Appl. No.: 09/597,192
Amdt. dated May 26, 2004
Reply to Office action of February 26, 2004

Amendments to the Drawings:

FIG. 8

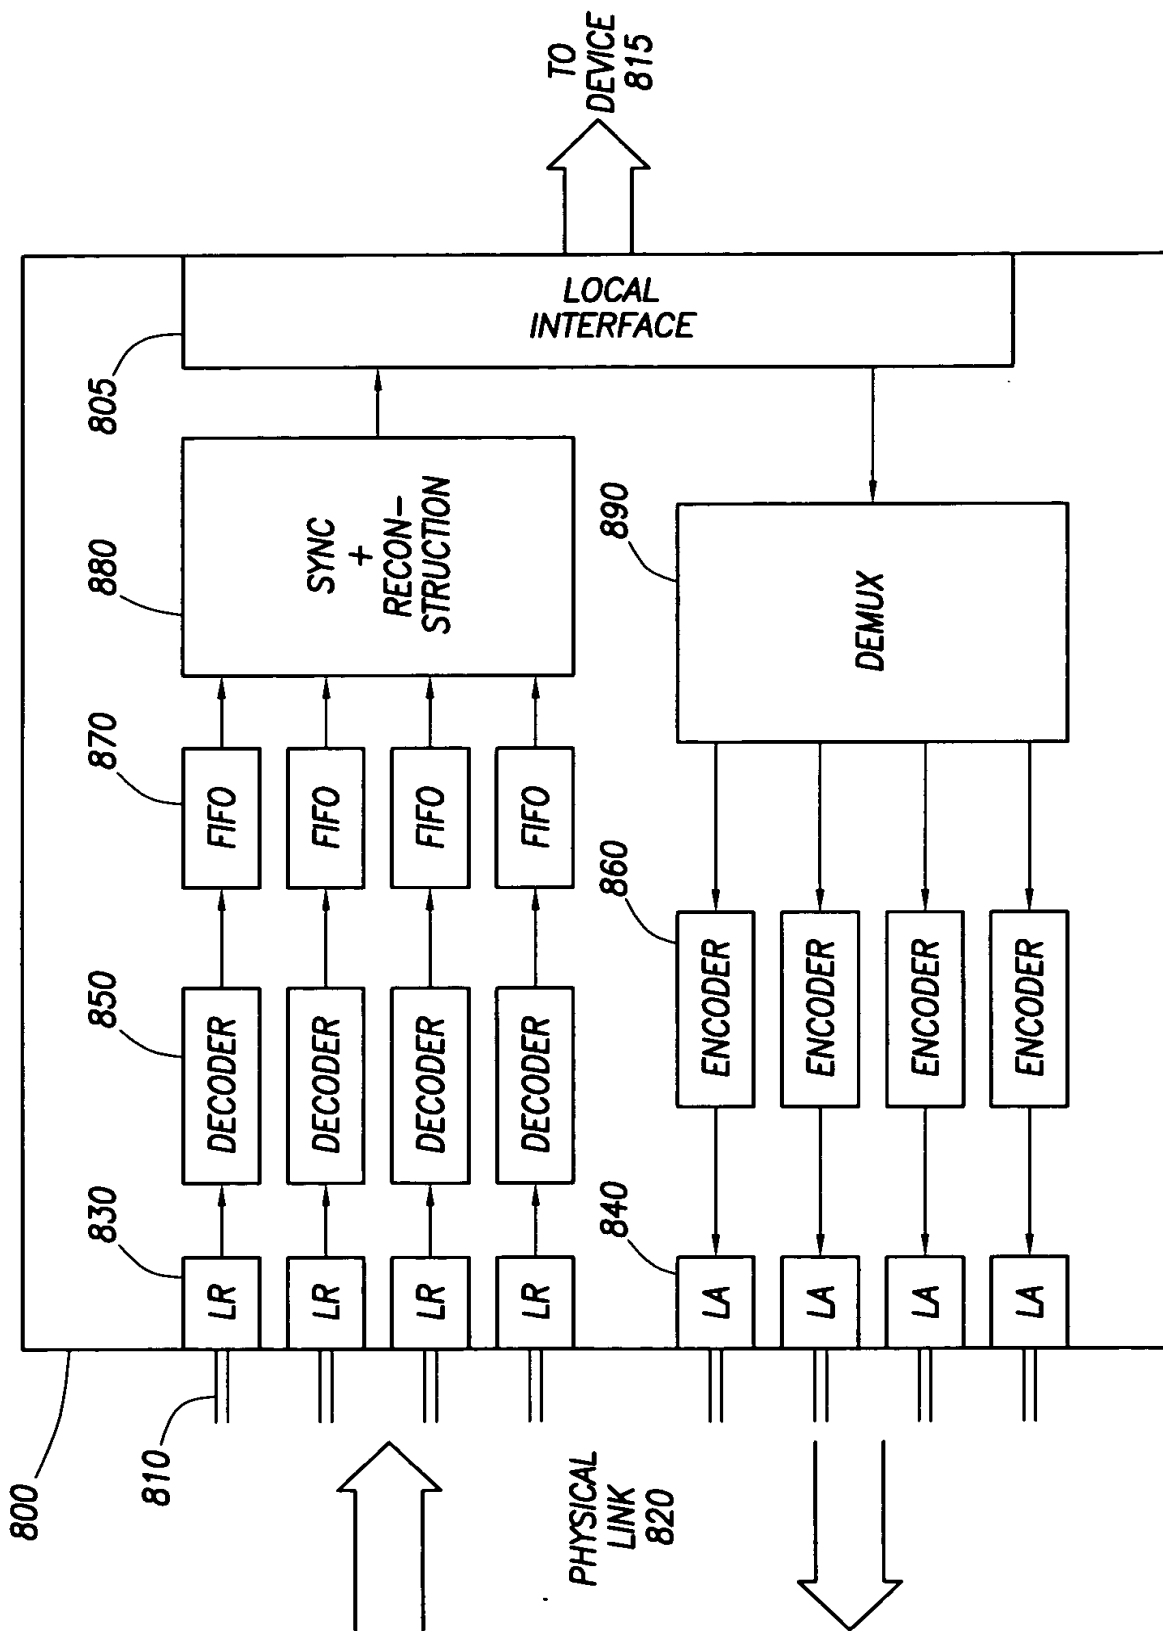
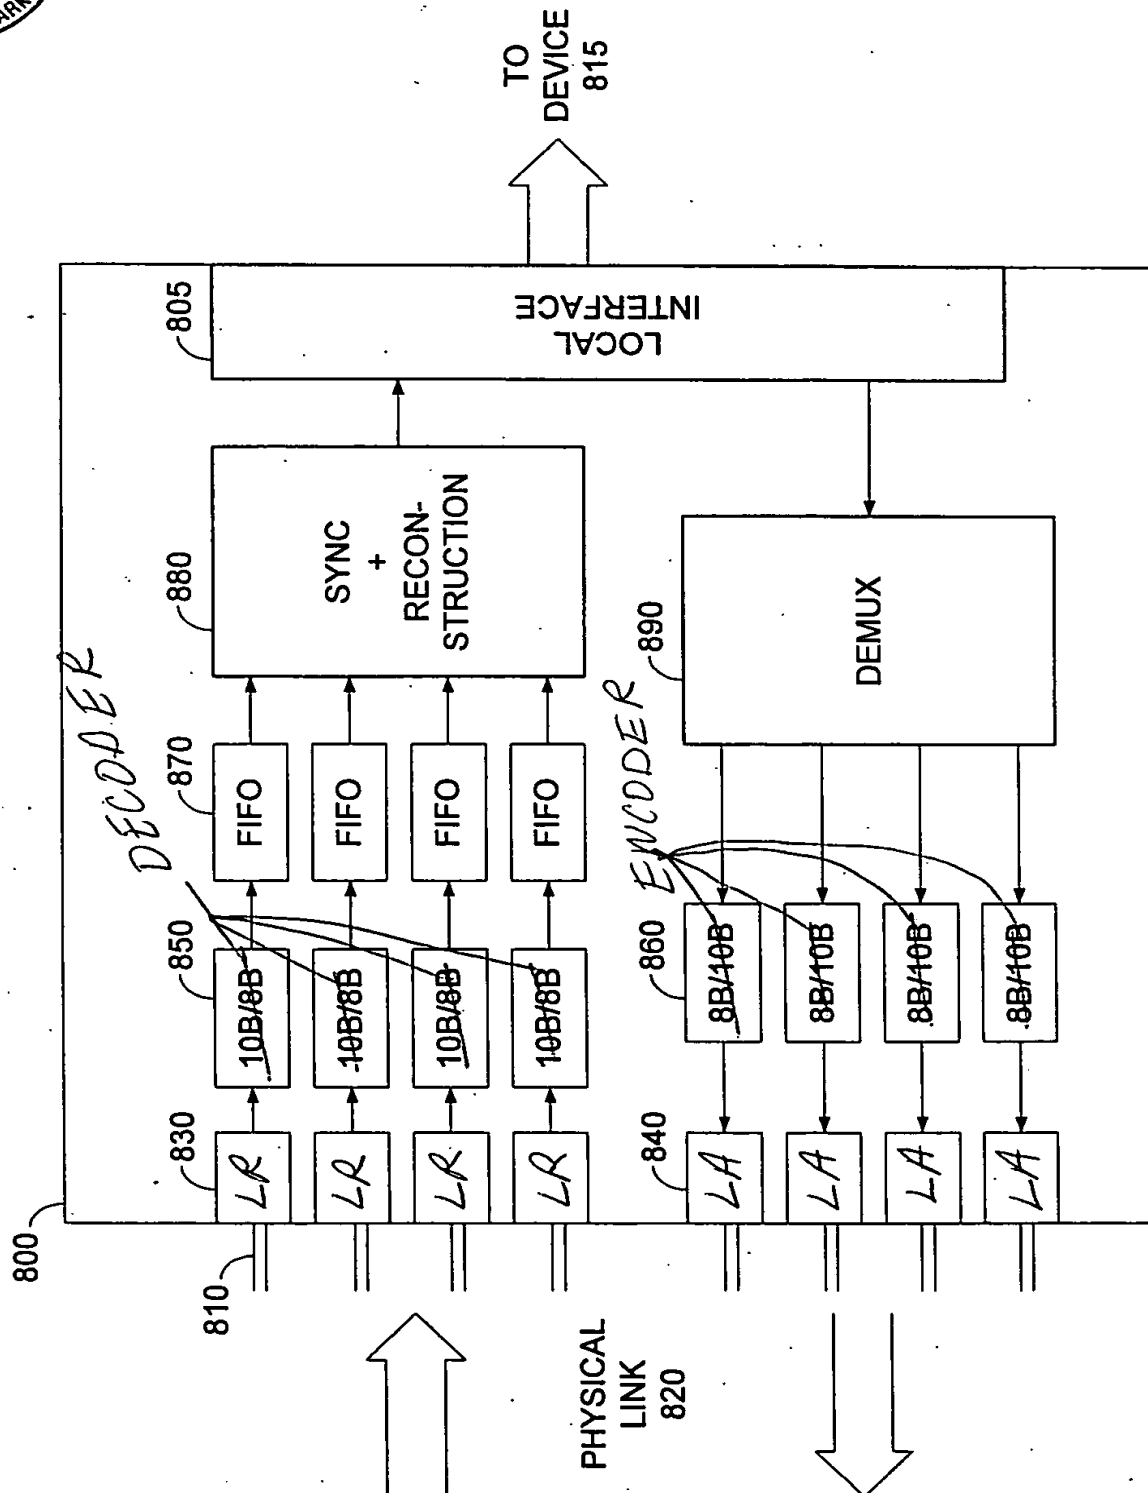
The attached sheet of drawings includes changes to Fig. 7 and Fig. 8. In Fig. 7, descriptive labels have been added to elements 700 and 710. In Fig. 8, descriptive labels have been added to elements 830, 840, 850, and 860.
